13 NOISE AND VIBRATION

13.1 INTRODUCTION

This chapter of the supplementary environmental impact statement for the proposed Queensland Curtis LNG (QCLNG) Project provides responses to noise and vibration related submissions received on the draft EIS of August 2009, where it pertains to the LNG Component of the Project. This chapter also presents, where relevant, additional information gathered on noise and vibration and provides an assessment and discussion of new or altered impacts as a result of amendments to the Project description since the publishing of the draft EIS.

Table 5.13.1 Summary of LNG Component noise and vibration submissions on the draft EIS

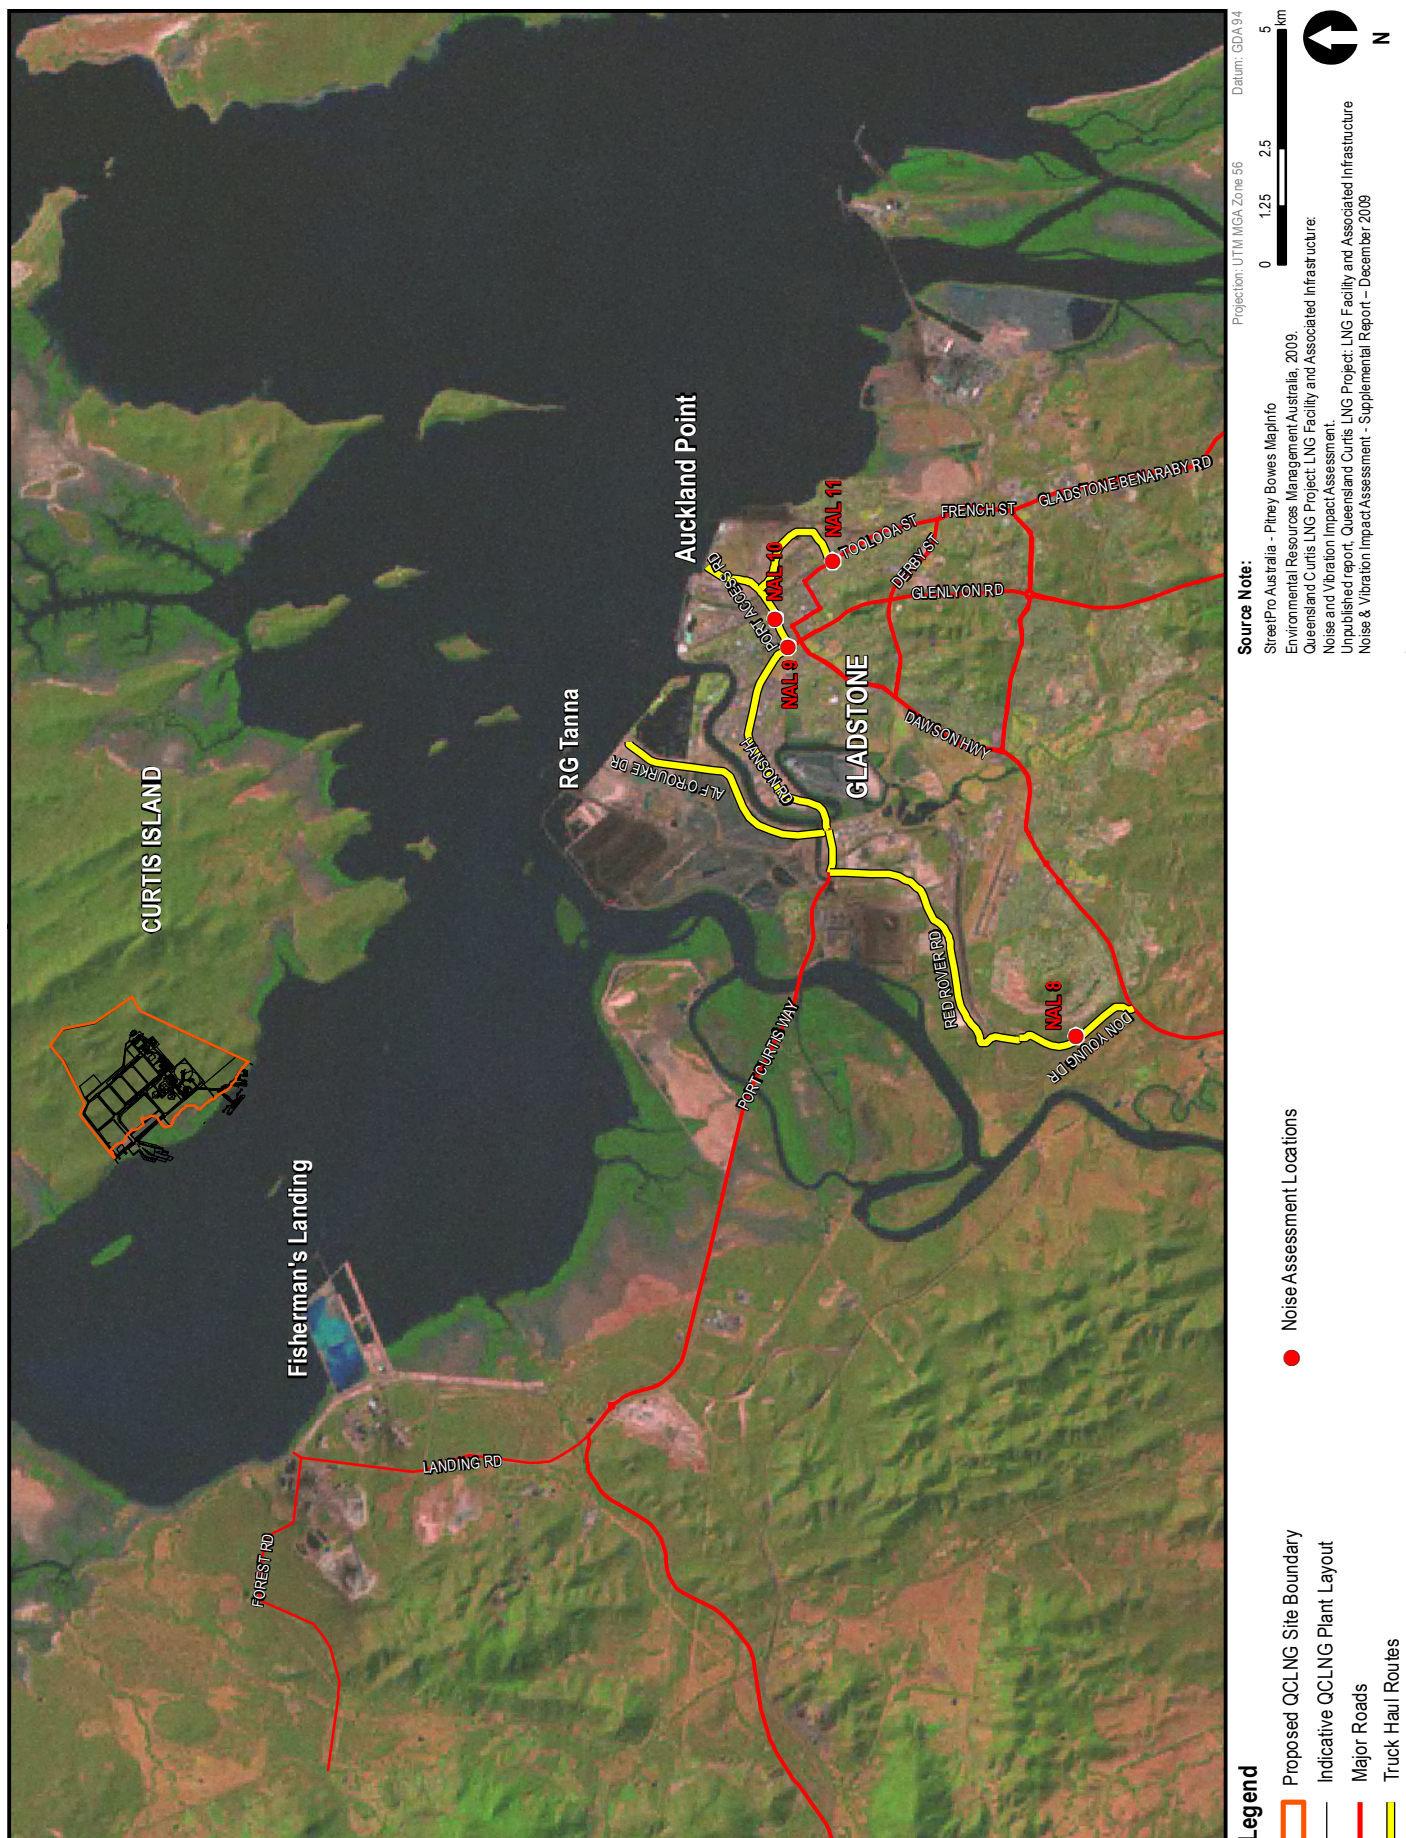
Summary of Submission	QCLNG Response	Submitter Number
Noise impacts of pipe unloading, stockpiling and transportation on residents near Auckland Point (including at Auckland Hill) need to be considered.	See <i>Section 13.3</i> for pipe handling and stockpiling noise impacts. Transportation noise impacts are addressed in <i>Section 13.6.2</i>	29
Cumulative impacts need to consider traffic noise from heavy vehicle transport of bulk materials and pipes.	See <i>Section 13.6.2</i>	29

Based on the latest available Project traffic numbers, the road traffic noise level at NAL8 (near Don Young Drive) is expected to increase by 1.5 dB(A), to approximately 61.5 dB(A). This remains well below the criterion of 68 dB(A) for increases in traffic on an existing road. At NAL9 (the western end of the Port Access Road), an increase of 240 truck movements per day would increase traffic noise levels by less than 1 dB(A) to 68-69 dB(A), due to the already high numbers of vehicles on Glenlyon Street and Port Access Road. NAL10 would experience a similar increase of about 1 dB(A), to a total of 72 dB(A).

The actual increase in noise level at NAL 9 and NAL 10 (Auckland Street near Port Access Road) will be less than that noted, as a percentage of the 240 trucks will travel to RG Tanna (via Alf O'Rourke Drive) and not to Auckland Point. While these levels are greater than the $L_{10}(18 \text{ hour})$ 68 dB(A) criterion, they are less than a 3 dB(A) increase considered to be significant. Therefore, haulage of bulk materials is not expected to cause significant noise impacts during the day and evening periods.

At night, traffic numbers indicate a Project peak night-time traffic load of six truck movements per hour for Don Young Drive, and 12 truck movements per hour for the Port Access Road. At this rate, individual vehicles passing by are separated by several minutes or more, and the noise levels experienced at residences are dependent upon individual vehicle noise emissions rather than the number of vehicles. Noise monitoring on-site showed existing truck pass-by noise levels of 72-79 dB(A). Noise from proposed trucks would be at a similar level. Therefore, although the number of vehicles passing by during the night would increase with the additional QCLNG traffic, the noise level of a typical pass-by would not.

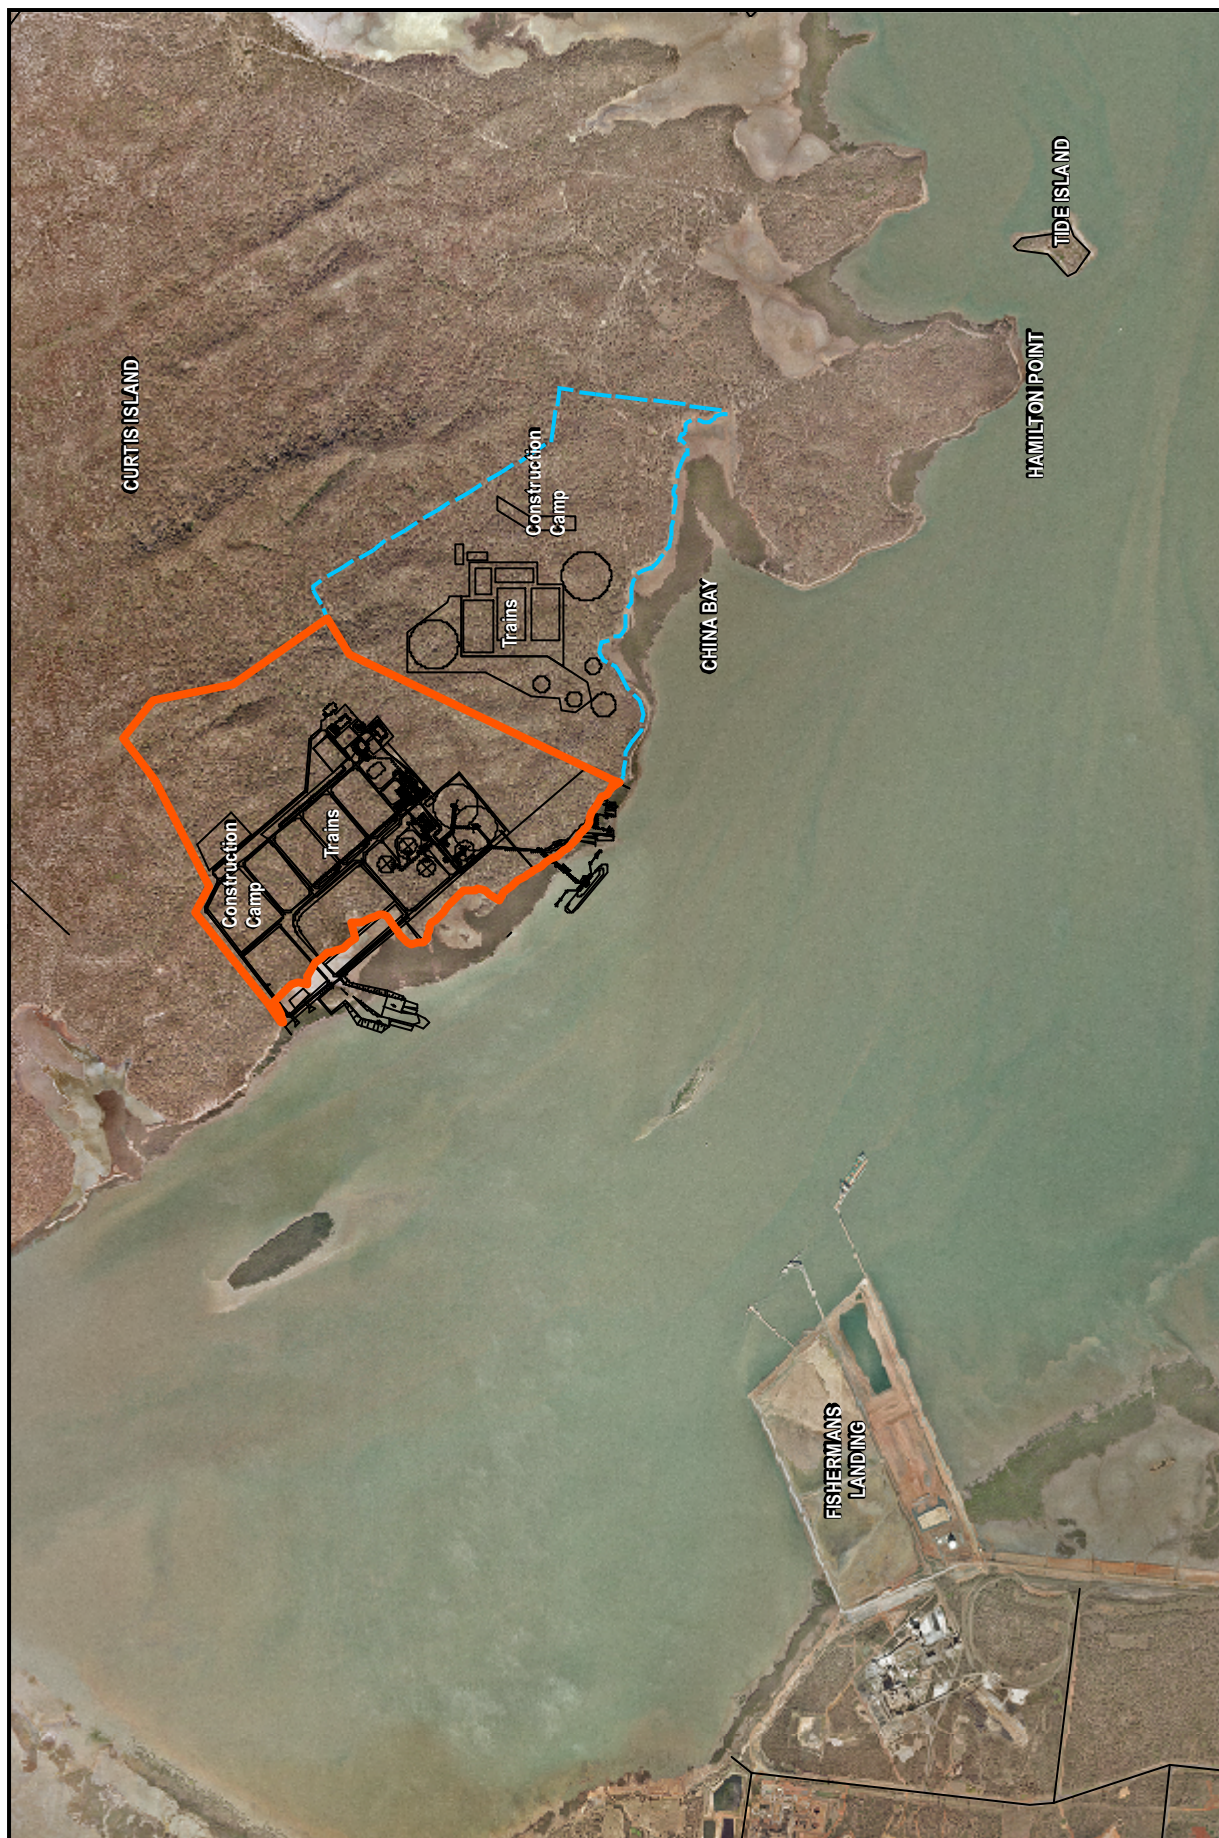
Summary of Submission	QCLNG Response	Submitter Number
Neighbouring LNG plants on Curtis Island should be considered the nearest noise-sensitive receptor. Potential noise impacts from QCLNG operations should be assessed and mitigation proposed.	See <i>Section 13.4.3</i>	32

There are no standard noise criteria for construction camps, as they are temporary in nature and while residential in use, they are built for the convenience of having the construction workforce in proximity to the work site. Depending on construction and operational timing, it is possible that the Gladstone LNG (GLNG) construction camp may be occupied when the QCLNG Facility is under construction or operating. The land use at this time would be industrial.

The relationship between the GLNG camp and the proposed QCLNG Plant is indicated in *Figure 5.13.3*.

estimated noise levels for future residential uses. For areas within predominantly industrial districts, AS1055 provides the following background noise levels: day 65 dB(A); evening 60 dB(A); and night 55 dB(A). When industries construct buildings on their own sites (including worker accommodation), they are required to be designed to meet acceptable internal noise levels (taking into account sleep disturbance and speech interference) for the types of external noise levels generated from their industrial noise sources. Hence, if the noise from an adjacent industry meets these levels then the impact from the QCLNG Plant should be acceptable.

As described in the GLNG EIS⁴, the GLNG camp (located at approximately RL20-24 m) will be located to the south-east of the plant. This is a favourable location from a noise perspective as the ridgeline (varying from RL32 m to RL56 m) situated immediately to the north-west shields the camp from the QCLNG site. Noise modelling predictions indicate that noise levels of 40-45 dB(A) would be experienced at the GLNG construction camp site during construction and operation of the QCLNG facility. These levels are below the background noise levels of 55 dB(A) expected for an industrial area at night, hence no significant noise impacts are expected at the GLNG camp.
